**APAC TRANSPORTATION STANDING COMMITTEE REPORT  
PROJECT FRONTIER CULTURAL RESOURCES REVIEW – April 19, 2023**

APAC Transportation Standing Committee offers the following preliminary analysis, comments, and questions on the *Project Frontier Transportation Impact Analysis Report* (TIAR) dated November 11, 2022 and responses to APAC of March 14, 2023. The 243-page TIAR report prepared by consultants Fehr & Peer contains extensive technical and statistical reference material that requires further validation and access to appropriate modeling tools. The APAC document was based on contributions from sixteen El Dorado Hills resident volunteers.

5. Page 5 (PDF Page 9) – Regulatory Setting:

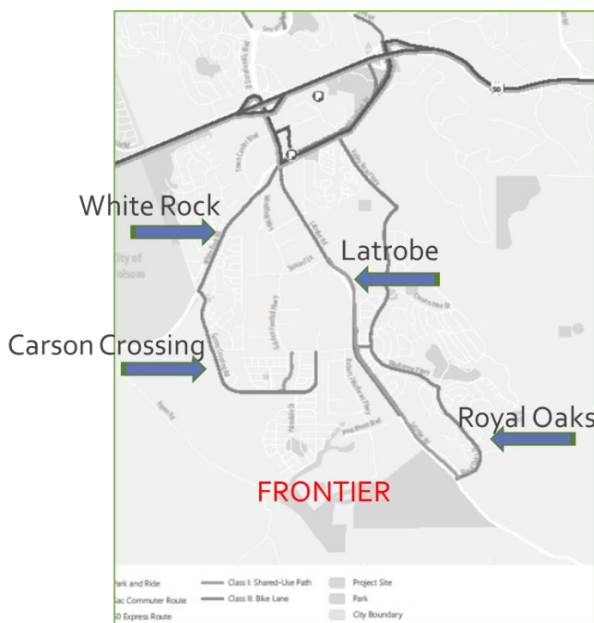
The last paragraph on this page states, “In Addition, the project is subject to Measure E, which was adopted June 6, 2016 and became official on July 29, 2016.” however no analysis was performed under this measure. Based on

the project's trip generation as determined by ITE standards (see item 3. above) there are numerous violations under Measure E. IE: a 15% increase was allowed by EDC due to COVID which has no basis.

CONCLUSION: The applicant should provide an analysis under Measure E. To say that Measure E is applicable and then fail to evaluate the traffic impacts under Measure E is negligent.

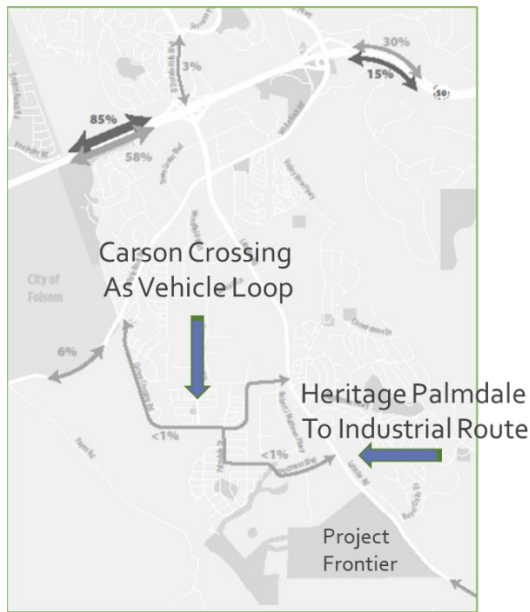
14. FACTUAL CHALLENGE: Speaking of Carson Crossing, see Figure 5 shows a loop that would move traffic onto Palmdale Road to Investment Road. The problem is that that segment is gated privately owned and maintained by the Heritage HOA. If the inclusion of this figure is the result of failure to perform due diligence, then the entire traffic study might be questioned. On the other hand, if the applicant and the county has made agreements to exercise rights that were granted as a condition for development of Heritage, those items must become transparent. This also calls into question other plans associated with Royal Oaks/Blackstone, Golden Foothills, etc. See below.

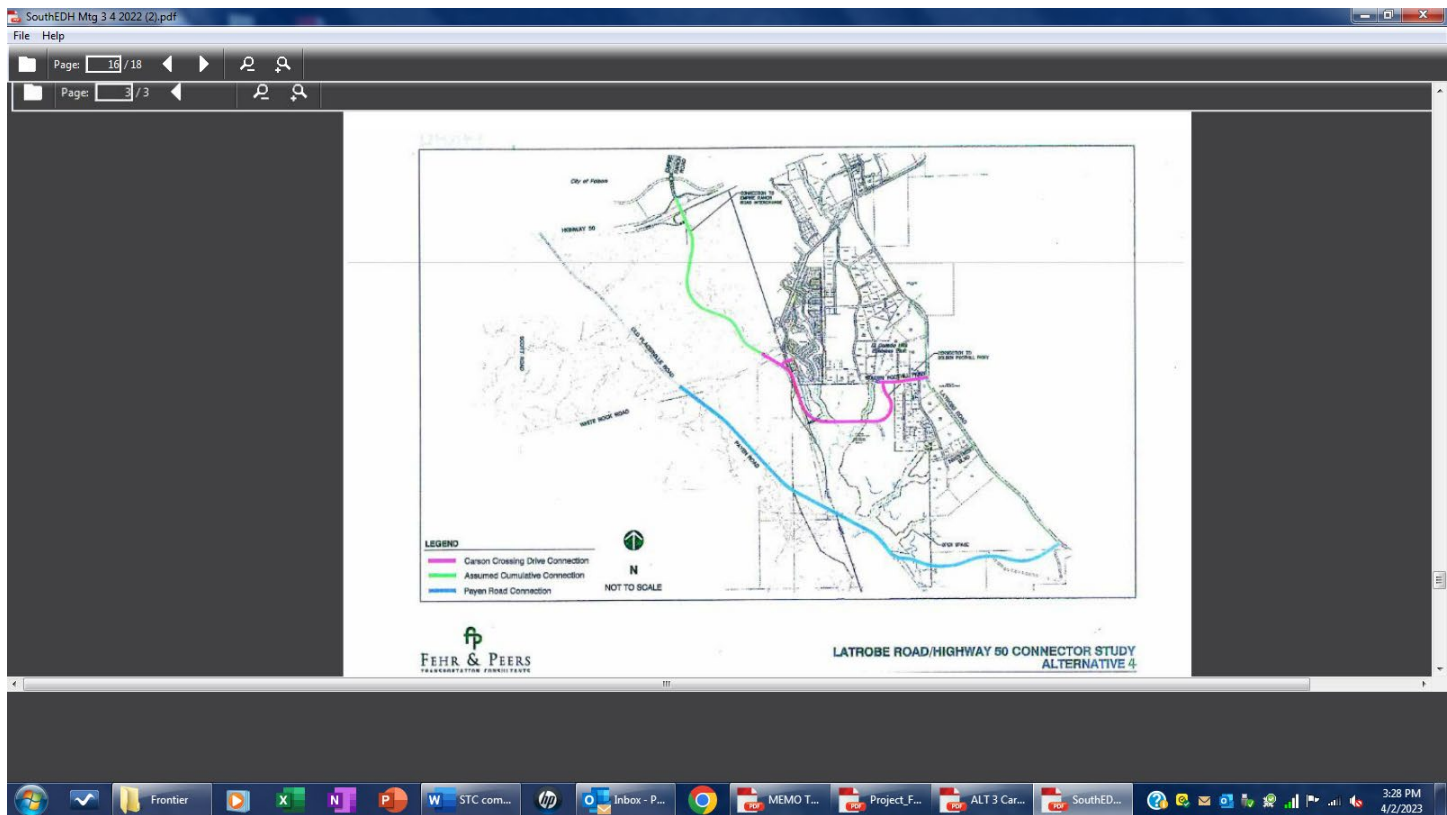
It also needs to be mentioned that EDC DOT is also investigating adding a new 2-4 roadway lane connection from White Rock/Empire Ranch Road to Carson Crossing as well as a new 2-4 roadway lane from White Rock/Placerville Road heading south on Payen Road, west of Four Seasons and Heritage and connecting to Latrobe Road at the new signal at Project Access C (south of Project Access B) which is a main exit from the center's facility. See preferred Alternative #4 (per EDC) below.

As mentioned in comment #14 above, Alternative #4 –White Rock/Payen Road to Latrobe Road (**new 2-4 lanes**) as well as (**new 2-4 lanes**) White Rock Road/Empire Ranch connection to Carson Crossing, west of Four Seasons and Heritage developments is under investigation.
